**CALIFORNIA COASTAL COMMISSION**

**RECORD PACKET COPY****STAFF REPORT AND RECOMMENDATION****ON THE INITIAL PHASE CONSISTENCY DETERMINATION**

Consistency Determination No. **CD-049-98**  
Staff: JRR-SF  
File Date: 4/10/1998  
45th Day: 5/25/1998  
60th Day: 6/9/1998  
Commission Meeting: 5/12/1998

Evolved Expendable Launch Vehicle Program (Exhibits 3, 4, 5, and 6)

**Concept A  
SLC-3W Site Plan,  
Vandenberg AFB,  
California**

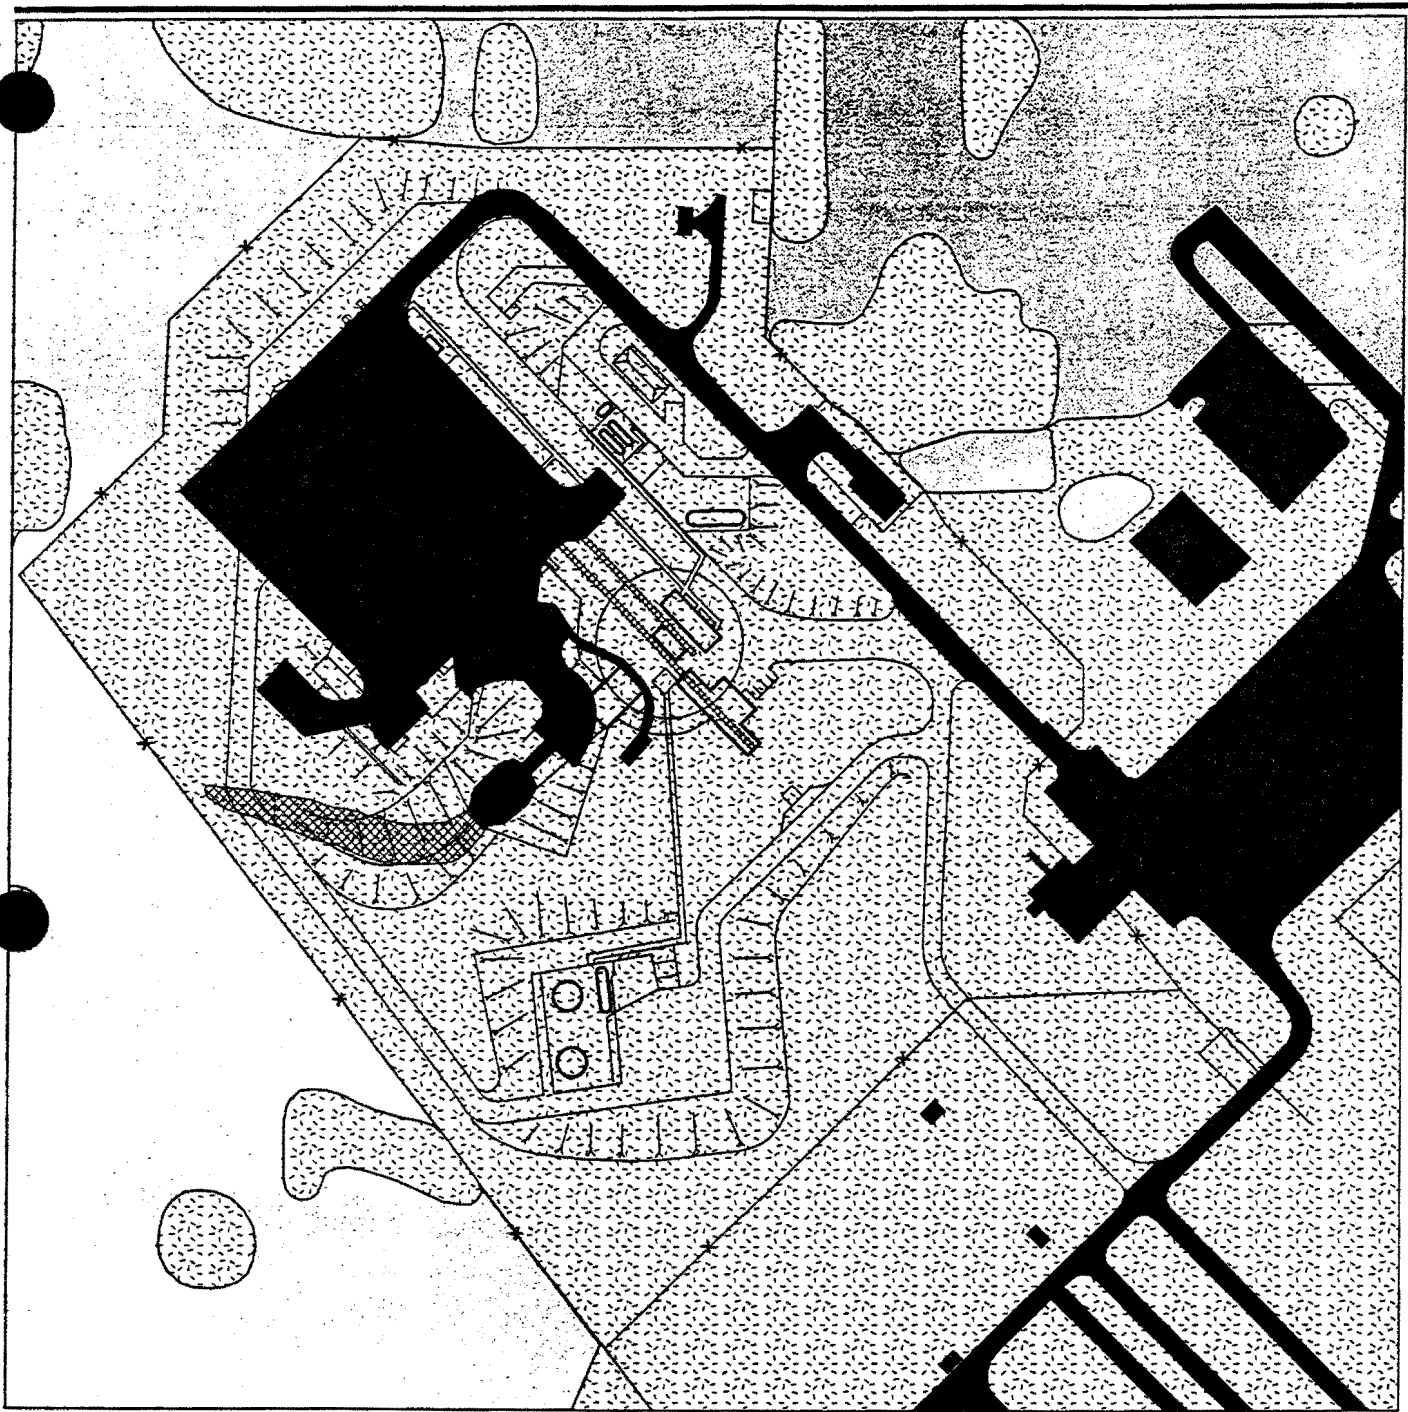
Originally, the proposed project included 0.03 acres of wetland fill. Although this is not a significant amount of habitat loss, the Air Force did not initially provide enough information for the Commission to evaluate the project's consistency with the wetland policies of the CCMP. Specifically, the modifications to the existing facility at SLC-3W included the construction of a second access road. That new road would have filled 0.03 acres of wetland. In its consistency determination, the Air Force describes the impact as follows:

Section 30233 of the Coastal Act provides three tests by which the Commission must evaluate wetland fill projects: allowable-use, alternatives, and mitigation tests. With respect to the first test, Section 30233 identifies eight allowable activities that can result in wetland fill. It appears that none of the allowable uses apply to this proposed road. Additionally, the Air Force did not provide enough information to demonstrate that the proposed road is the least damaging feasible alternative. Finally, although the Air Force stated that it would mitigate for the fill, it did not provide any details on that mitigation.

In response to these concerns, the Air Force agreed to withdraw the road from the Commission's consideration at this time (Exhibit 14). The Air Force proposes to reconsider the need for the proposed road. If it concludes that the road is necessary, the Air Force will provide additional information to demonstrate that the road is either consistent with Section 30233(a) of the Coastal Act or that the maximum extent practicable standard in the Coastal Zone Management Act applies in this case. Since the

**Typical Impact Debris Corridors, SLC-3W**

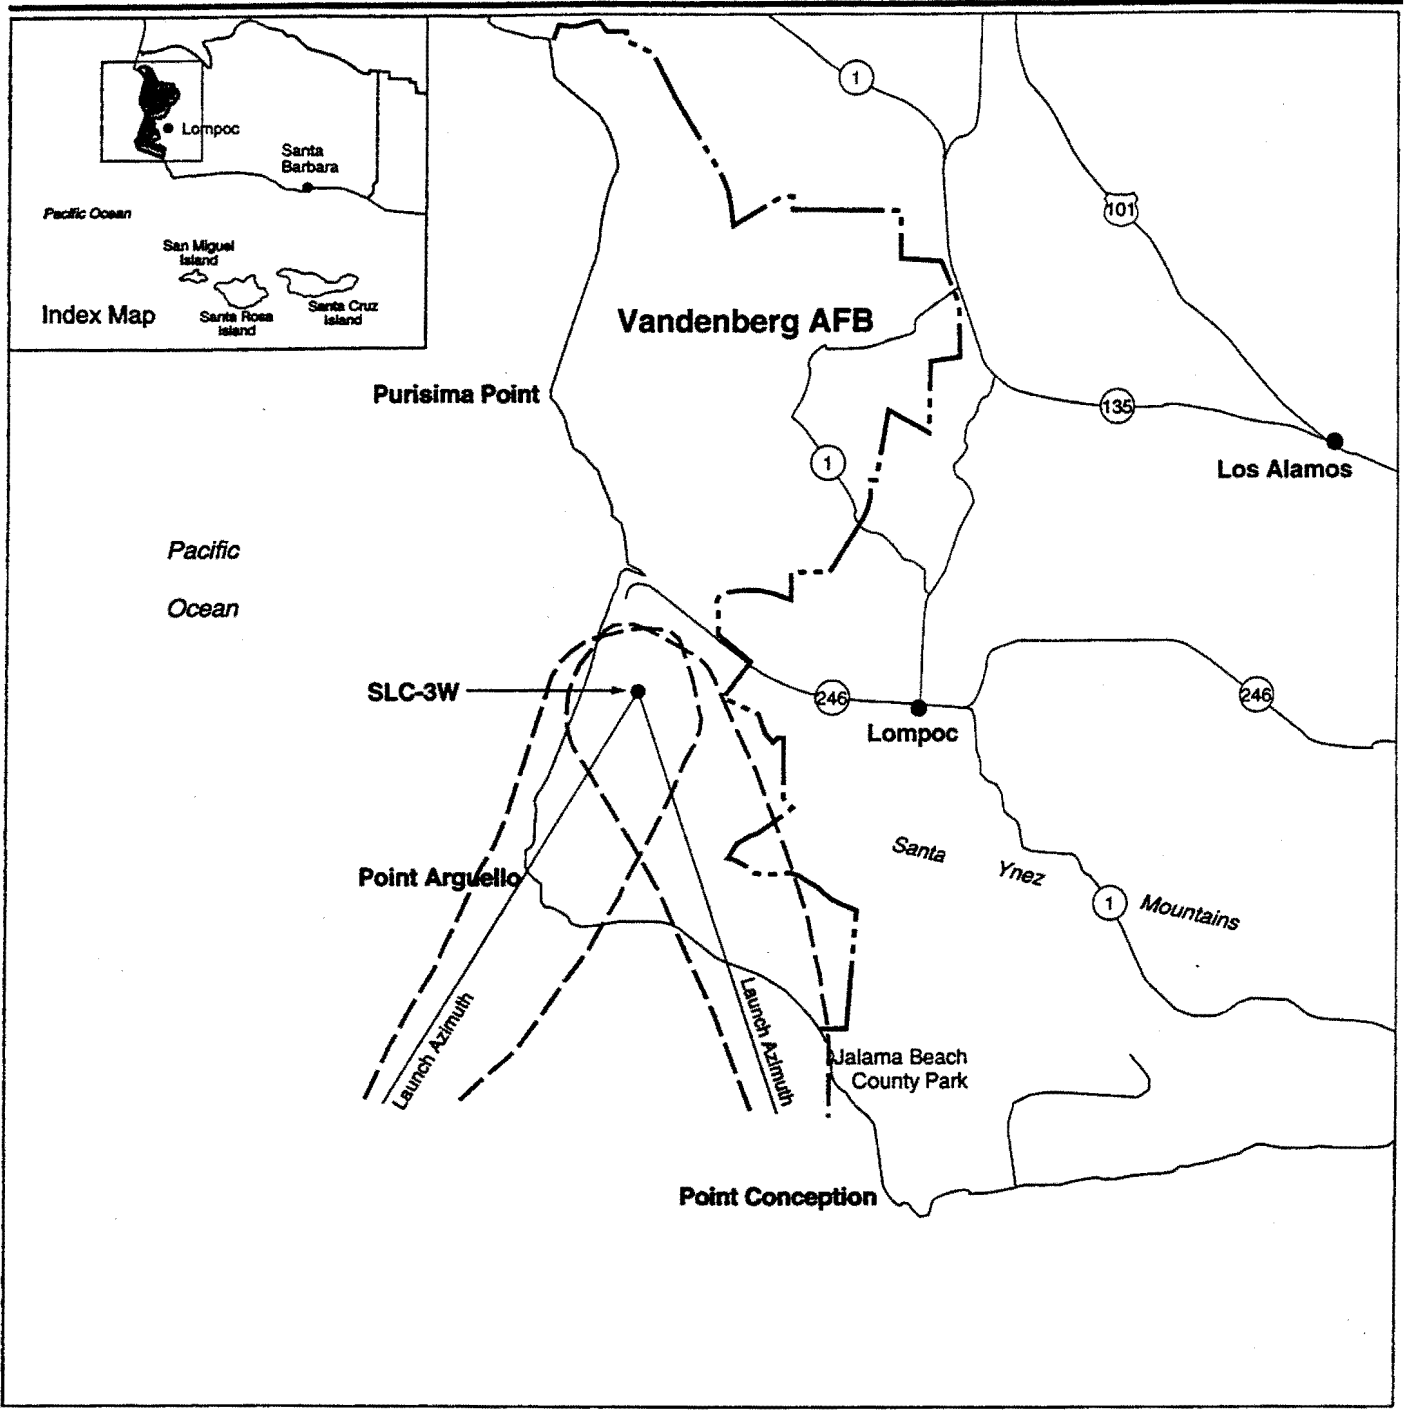
The proposed project involves launches from two locations, SLC-3W and SLC-6. Depending on the trajectory, launches from SLC-3W (Exhibit 10) could require closures of both Jalama Beach County Park and Ocean Beach County Park. Additionally, launches from SLC-6 (Exhibit 11) could require the closure of Jalama Beach. These beaches are two of only four public beaches within the 64-mile stretch of northern Santa Barbara County: Gaviota Beach, Jalama Beach, Ocean Beach, and Point Sal.
